King Street Pump Station Improvements (Volume I) & ASR Lime System Improvements (Volume II) - RFCSP
Solicitation Number: CO-00670
Job No.: 20-6002 and 22-8603

ADDENDUM 12
January 09, 2024

LIME AND PERMANGANATE SILOS PLAN VIEW
SCALE: 1/4" = 1'-0"

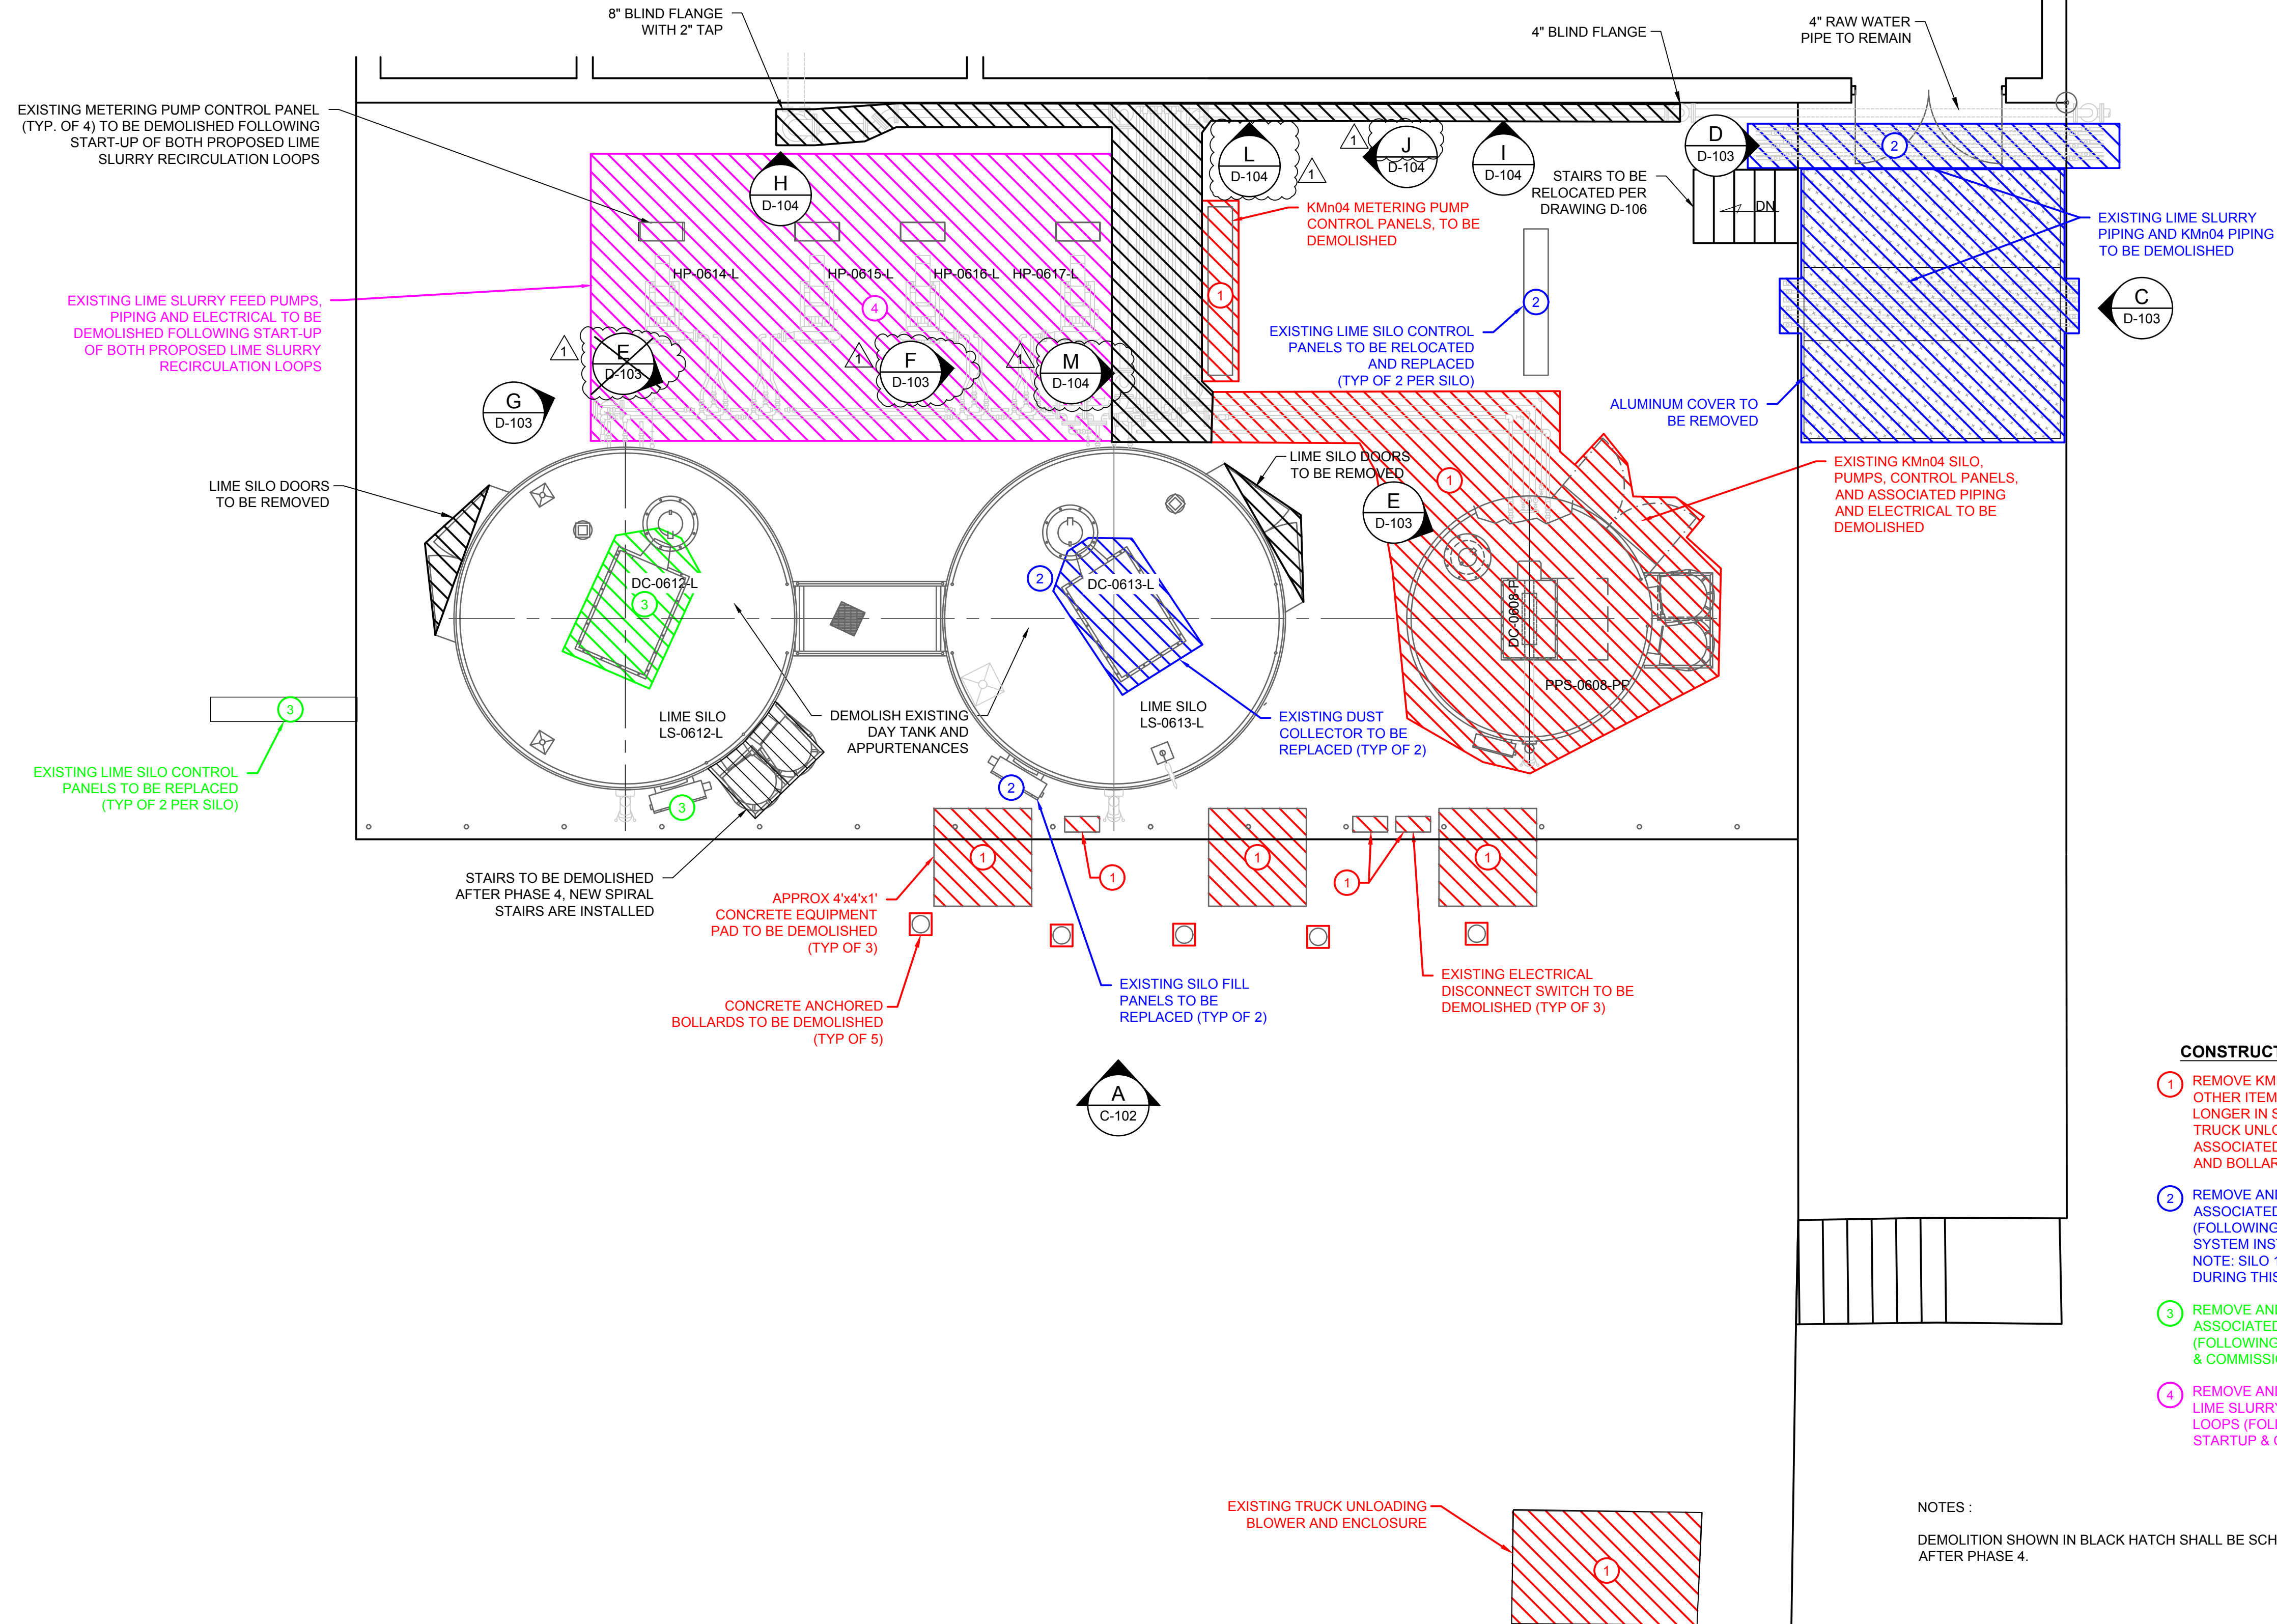
- 1. Volume II-ASR Lime Improvements: Contract Drawing D-101 shows where the Demo Pictures were taken from, however, Picture A / D-103 doesn't appear to be the correct location. Please Advise.**

- 2. Volume II-ASR Lime Improvements: Contract Drawing D-101 shows where the Demo Pictures were taken from, however, Picture B / D-103 isn't shown on D-101. Please Advise.**

- 3. Volume II-ASR Lime Improvements: Contract Drawing D-101 shows where the Demo Pictures were taken from, however, Picture E / D-103 is called out at different locations. Please Advise.**

- 4. Volume II-ASR Lime Improvements: Contract Drawing D-101 shows where the Demo Pictures were taken from, however, Picture F / D-103 isn't shown on D-101. Please Advise.**

Response: Reference for F / D-103 has been added to Drawing D-101. Refer to "Changes to Plans" Item No 1.
- 5. Volume II-ASR Lime Improvements: Contract Drawing D-101 shows where the Demo Pictures were taken from, however, Picture D / D-104 is shown, but not found on D-104. Please Advise.**

Response: D / D-104 reference has been updated to J/D-104 on Drawing D-101. Refer to "Changes to Plans" Item No 1.
- 6. Volume II-ASR Lime Improvements: Contract Drawing D-101 shows where the Demo Pictures were taken from, however, Picture J / D-104 isn't shown on D-101. Please Advise.**

Response: D / D-104 reference has been updated to J / D-104 on Drawing D-101. Refer to "Changes to Plans" Item No 1.
- 7. Volume II-ASR Lime Improvements: Contract Drawing D-101 shows where the Demo Pictures were taken from, however, Picture L / D-104 isn't shown on D-101. Please Advise.**

8. **Volume II-ASR Lime Improvements: Contract Drawing D-101 shows where the Demo Pictures were taken from, however, Picture M / D-104 isn't shown on D-101. Please Advise.**

Response: Picture E / D-103 refers to permanganate pumps as called out on Drawing D-101. Duplicate reference for E / D-103 has been deleted from Drawing D-101. Refer to "Changes to Plans" Item No 1.

1. DRAWING D-101: LIME FEED SYSTEM DEMOLITION PLAN
 - DELETE in its entirety and REPLACE with the attached.
2. DRAWING G-001 DRAWING INDEX
 - DELETE in its entirety and REPLACE with the attached.

1 OVERALL EQUIPMENT PLAN
SCALE: 1/4" = 1'-0"

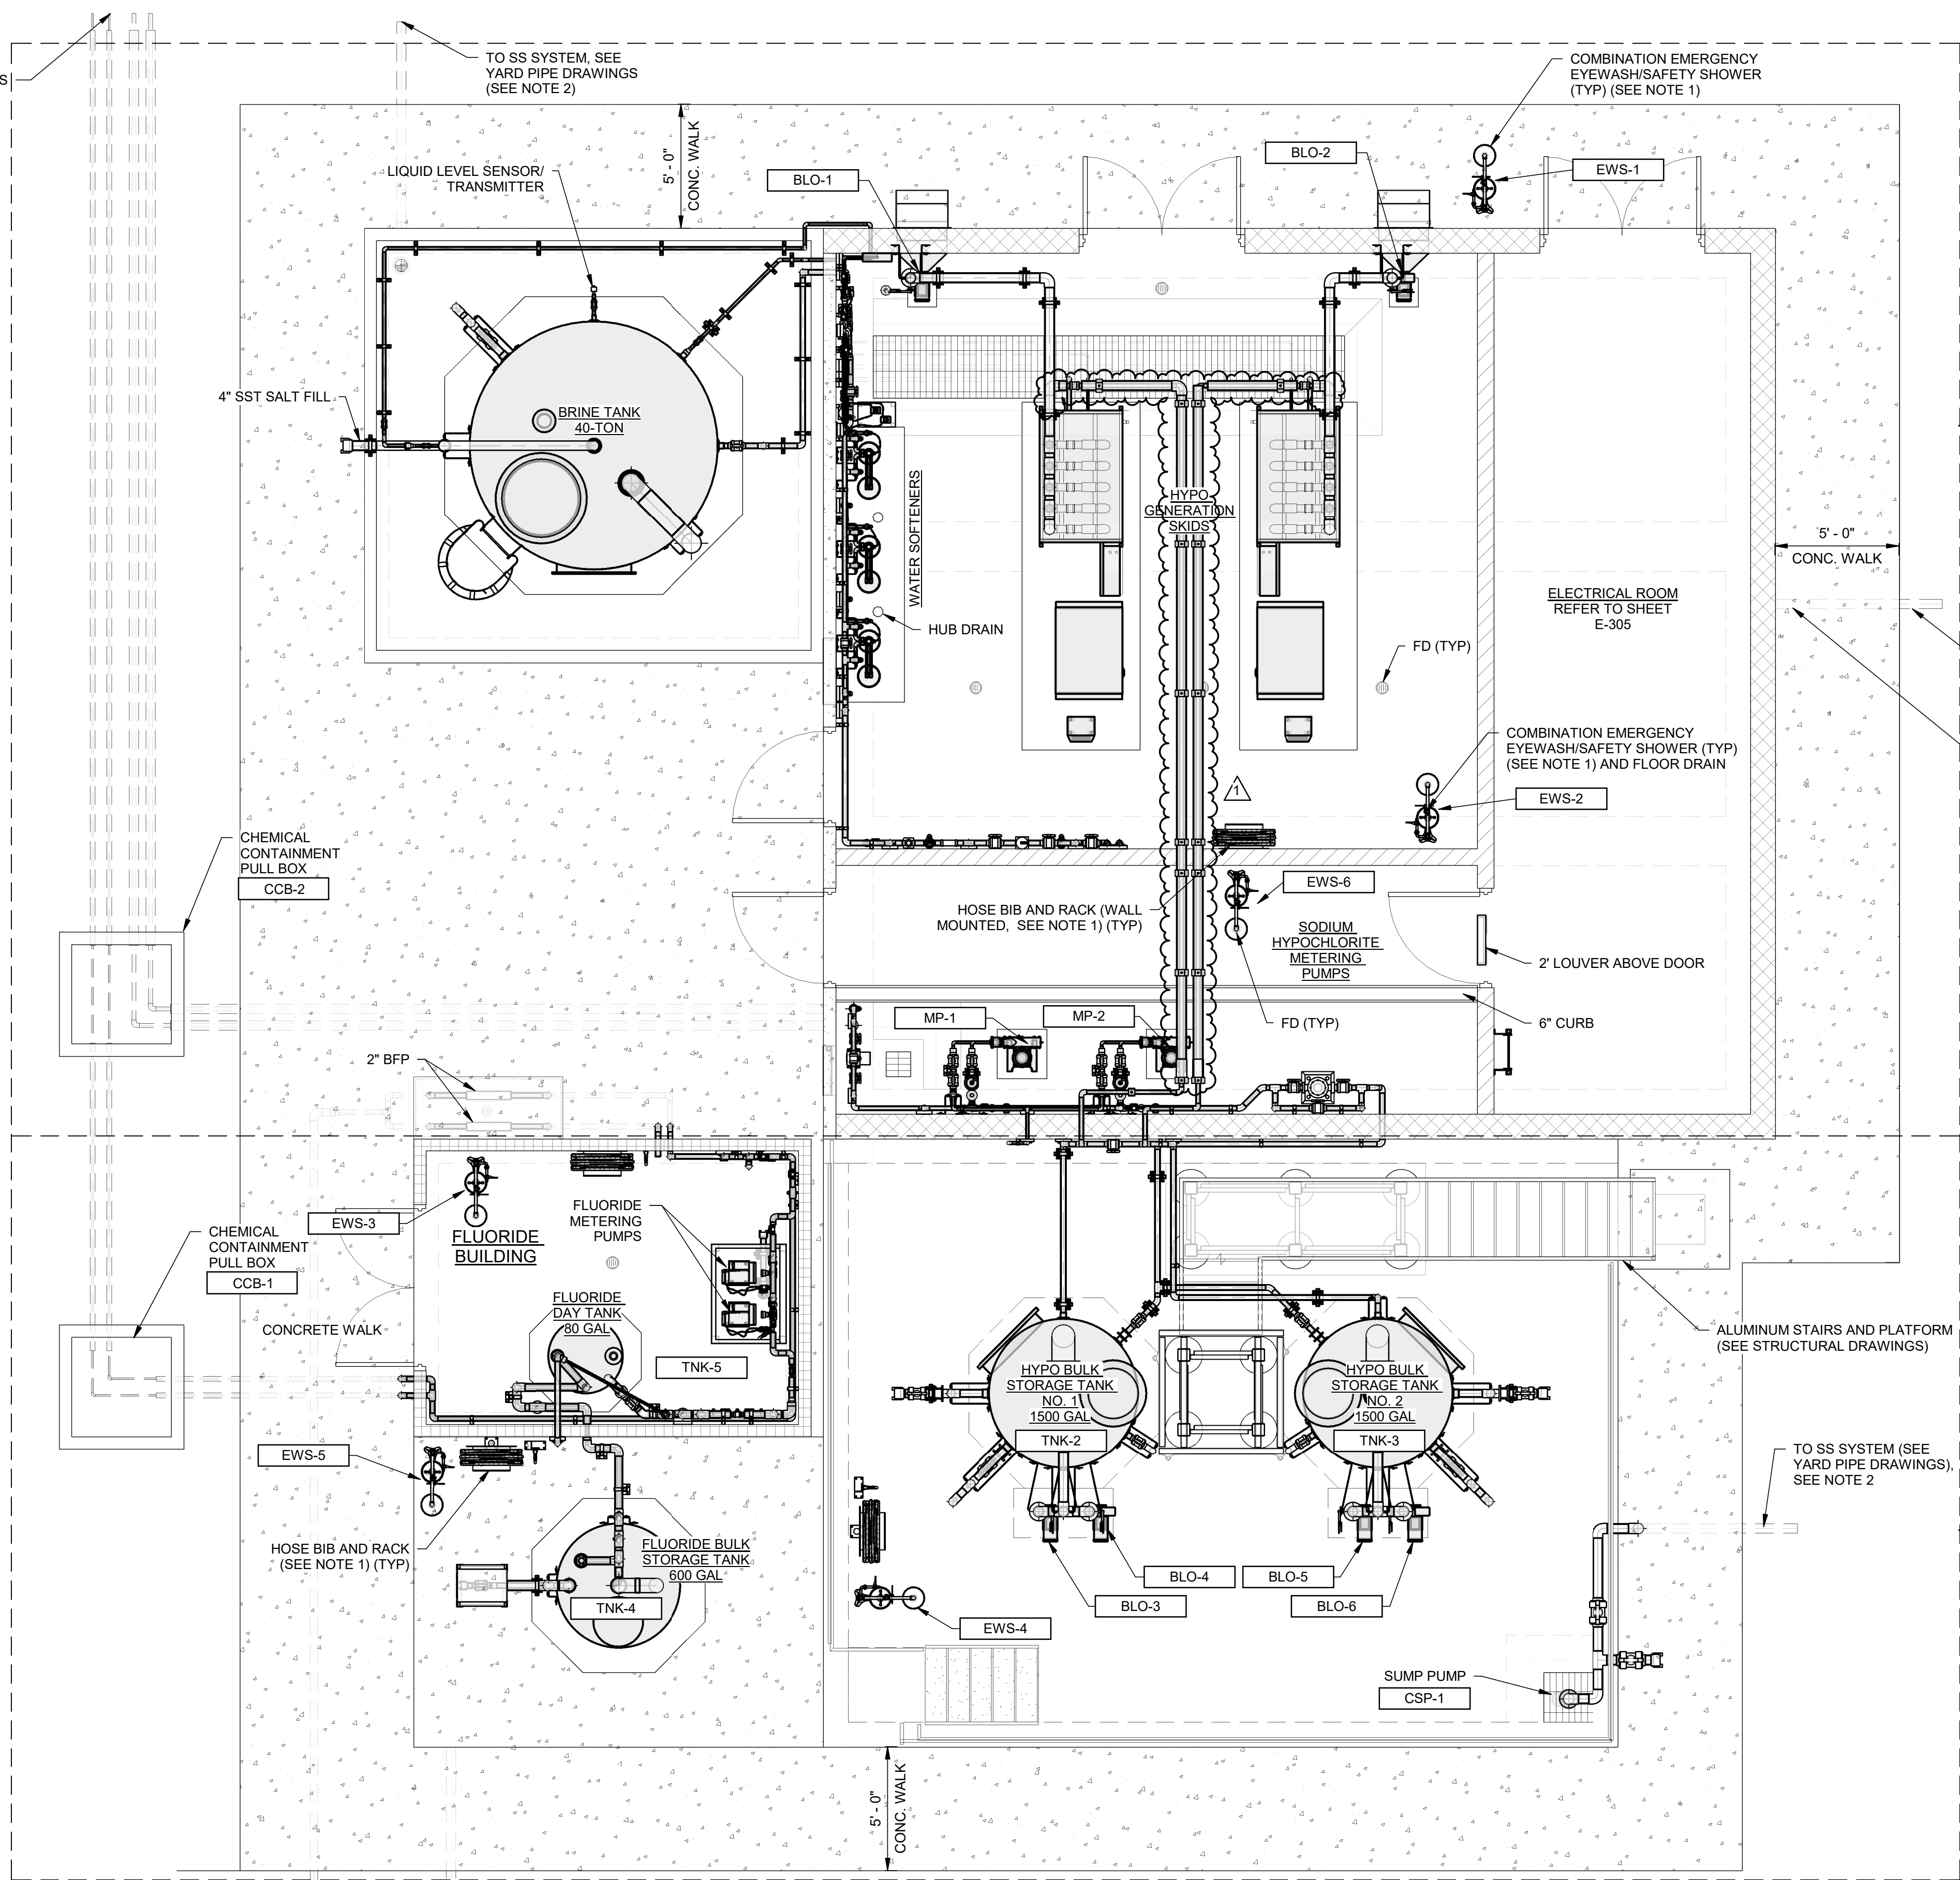
10. **Volume I-King St PS Improvements: The "PIPE MATERIALS SCHEDULE" table in drawing D-001 lists both fluoride and hypo systems as double contained. In the subsequent drawings the Fluoride systems has visible double containment, tags showing so, and tags showing the location of the low point leak detection sensors. In the Hypo system there is no visible double containment nor tags for the exposed/above ground portion, or defined locations for the leak detection. We want to confirm what are the above ground locations where the Hypo system needs double containment.**

Response: Double containment and leak sensors for hypo system shown. Refer to "Changes to Plans" Item No 5, Item No 6, Item No 7, Item No 8, Item No 9, Item No 11, Item No 12, Item No 13 and Item No 14.

- DELETE in its entirety and REPLACE with the attached.
5. DRAWING D-301: OVERALL EQUIPMENT PLAN
 - DELETE in its entirety and REPLACE with the attached.
